**PUBLIC INTEREST REVIEW FOR GROUND WATER APPLICATIONS**

SUBJECT: Application G- 17422 Supersedes review of \_\_\_\_\_  
Date of Review(s)

**A. GENERAL INFORMATION:** Applicant's Name: LaPine Water District County: Deschutes

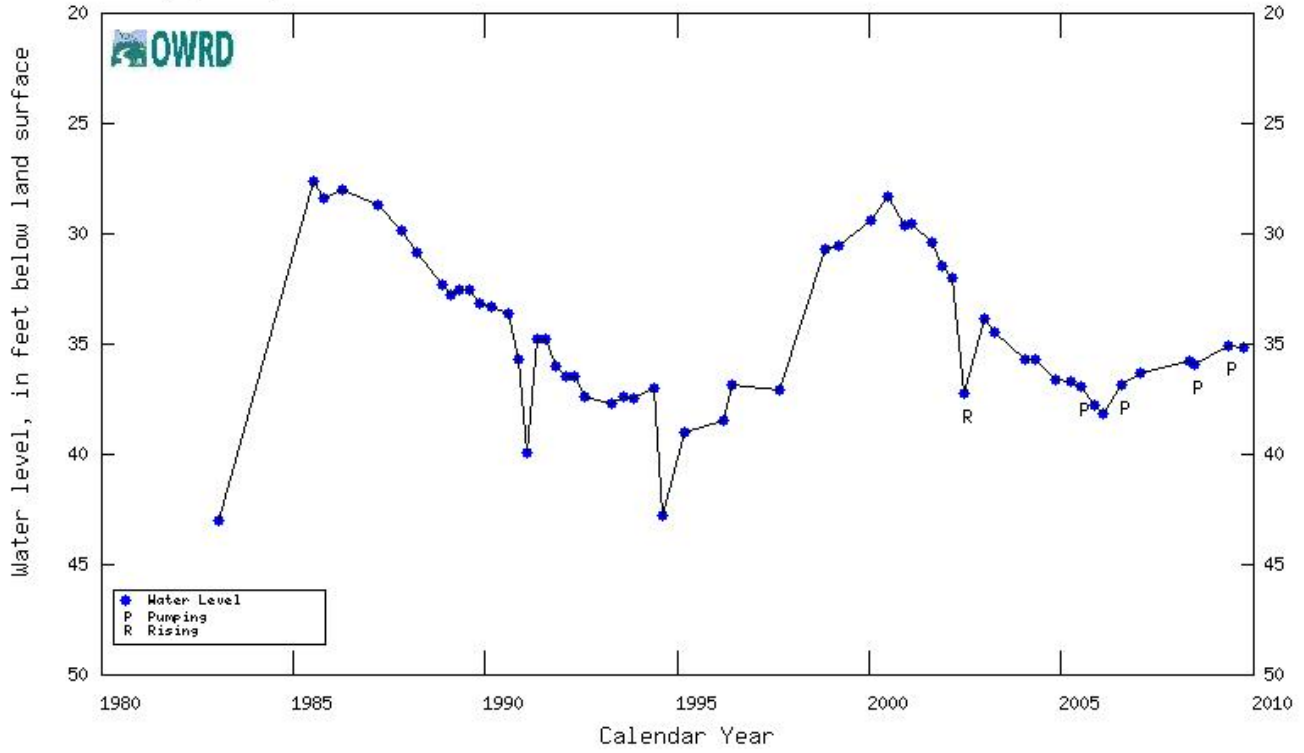
B3. **Ground water availability remarks:** THE NEAREST STATE OBSERVATION WELL IS OBS WELL 1084 (DESC 8108), ABOUT 2.9 MILES TO THE WEST-NORTHWEST. IT HAS BEEN MONITORED PERIODICALLY SINCE 1985. STATE OBSERVATION WELL 1084 APPEARS TO BE IN DYNAMIC EQUILIBRIUM. THE LONG-TERM TREND SHOWS A DECADAL-SCALE WATER LEVEL FLUCTUATION THAT IS COINCIDENT WITH CLIMATE CYCLES. THE DECADAL FLUCTUATION HAS A MAXIMUM AMPLITUDE OF APPROXIMATELY 10-12 FEET. SINCE 2000, THE WATER LEVEL HAD DROPPED ABOUT 8 FEET, BUT RECENTLY RECOVERED 1-2 FEET. LIKELY, MOST AS A RESULT OF CLIMATE FLUCTUATION.

THERE ARE NO WATER LEVEL MEASUREMENTS AVAILABLE AT THE PROPOSED POA'S SUBSEQUENT TO THE ISSUANCE OF THE ORIGINAL PERMIT (G-13444) FOR 2.23 CFS. THE POTENTIAL DRAWDOWN FROM THE RELATIVELY LARGE TOTAL PUMPING RATE PROPOSED AT THE POA'S (3.65 CFS) IS UNKNOWN.

ANNUAL WATER LEVEL MEASUREMENTS AND WATER LEVEL DECLINE CONDITIONS ARE RECOMMENDED.
